ALTOONA CITY PLANNING COMMISSION

Regular Meeting of Tuesday, July 7, 2026 at 3:00 PM
4th Floor City Hall Common Room

PROJECT – Blaise Alexander Hyundai Expansion

RE: Blaise Alexander Hyundai Building Expansion
Land Development Review

TYPE M INLET TOP

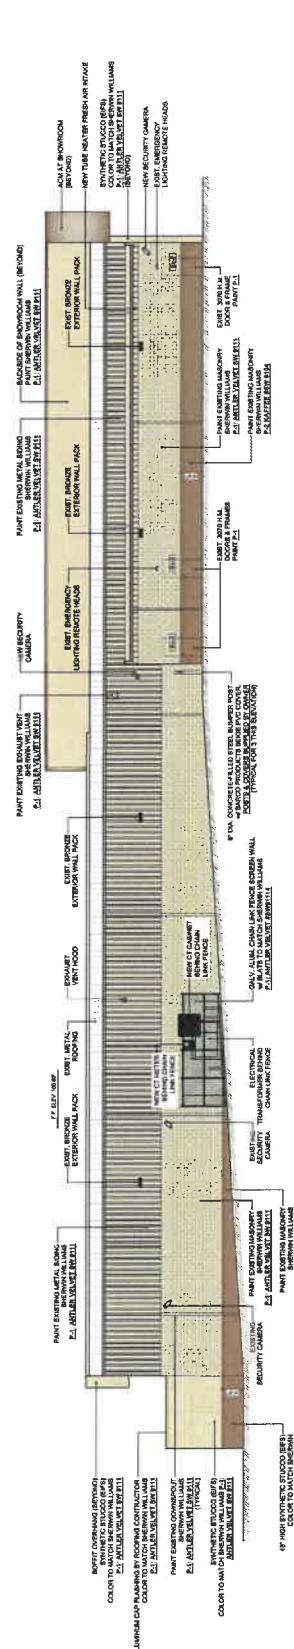
- The Pond Report indicates the outfall pipe out of outlet structure 1 is only 1.25" instead of 15", please revise.
 - The orifice plate detail shows a 4" wide crest length instead of the 4 ft wide crest indicated on the Pond Report. Additionally, the plate should be attached so that the entire 4' width is realized and there should be enough space over the plate to accommodate the 100-year storm before the inlet is narrowed for the type M inlet top. Provide dimensions/inverts on the Type 4 box to assure this.

6. The inverts and height of stone information has been added to the ADS Pipe Detention Details on Sheet 7. The outlet pipe diameter has been corrected. The orifice plate and inlet box details have also been revised as requested.

SOUTH ELEVATION
Scale: 3/32" = 1'-0"

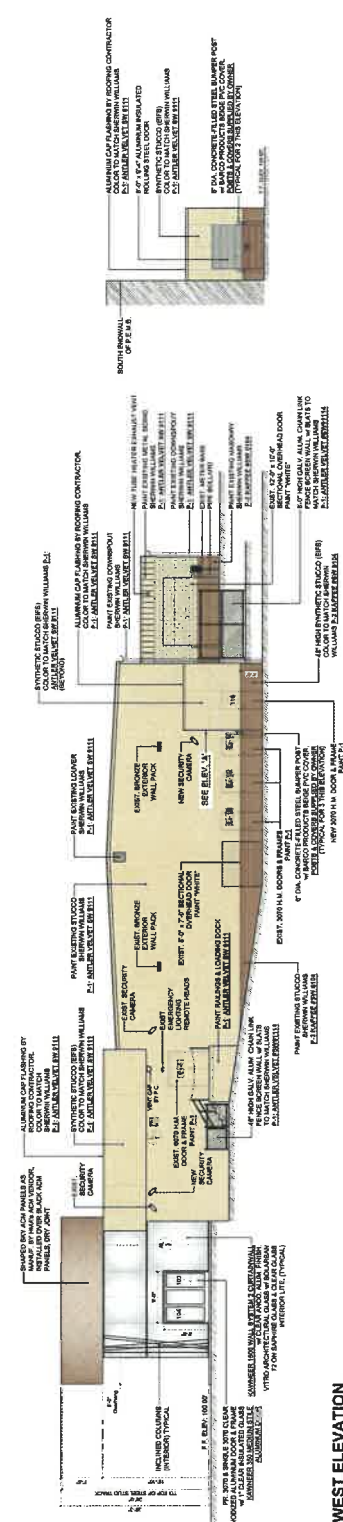
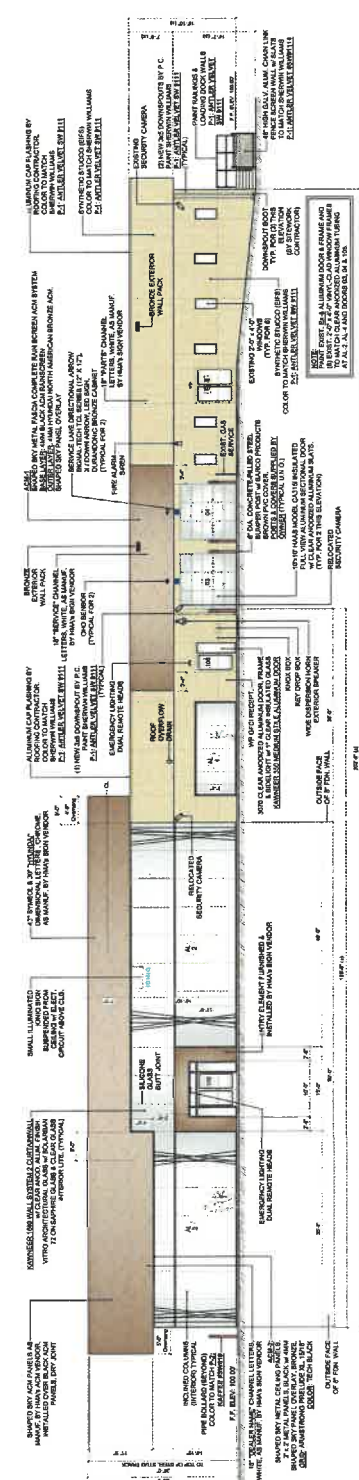
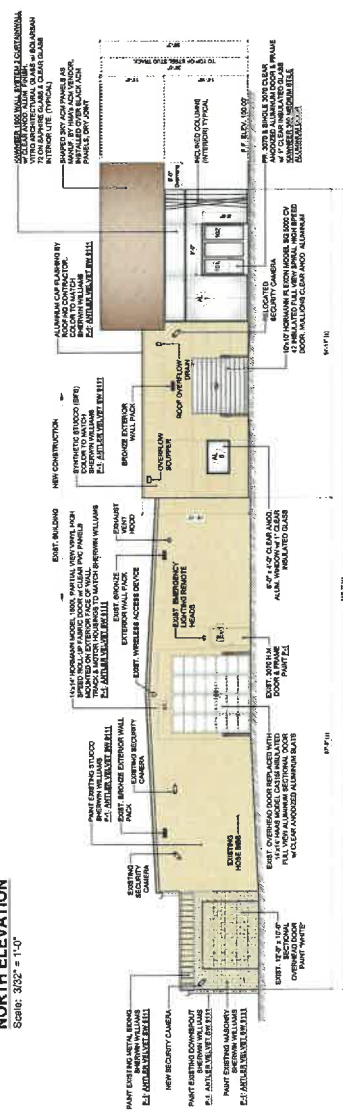
18. 640-35.A(6) Change the inscription on the cover to state "Altoona Planning **and Zoning** Administrator.
19. 640-35.A(14) The major site plan shall include architectural elevation drawings (with materials noted) of anticipated structures, parking areas, landscaped areas, signs, dumpster and utility enclosures, fences and other structures.

- Architectural drawings to be submitted to the city.
 - Please add sop signs at the exit points.
20. 640-35.A(17) If the plan submitted has been relieved of certain zoning requirements by a decision of the Zoning Hearing Board, the following shall appear on the plan: "Subject to an action taken by the Altoona Zoning Hearing Board on (Date)."

19. Elevation drawings have been added as the new sheets 9 and 10. Stop signs have been added to the exit points.
20. This note will be added if the plan is relieved of zoning requirements.
21. Noted.

34. The architectural elevations provided (Sheets 9 and 10) show conformance with these sections.
35. We ask that the sidewalk requirement along Pleasant Valley Boulevard be waived due to topographic and environmental constraints. The slopes/drainageway of the ditch along Pleasant Valley Boulevard makes sidewalk construction physically impractical without significant environmental disruption. The required fee for the "In Lieu of Sidewalk" fund will be paid once this waiver is granted.
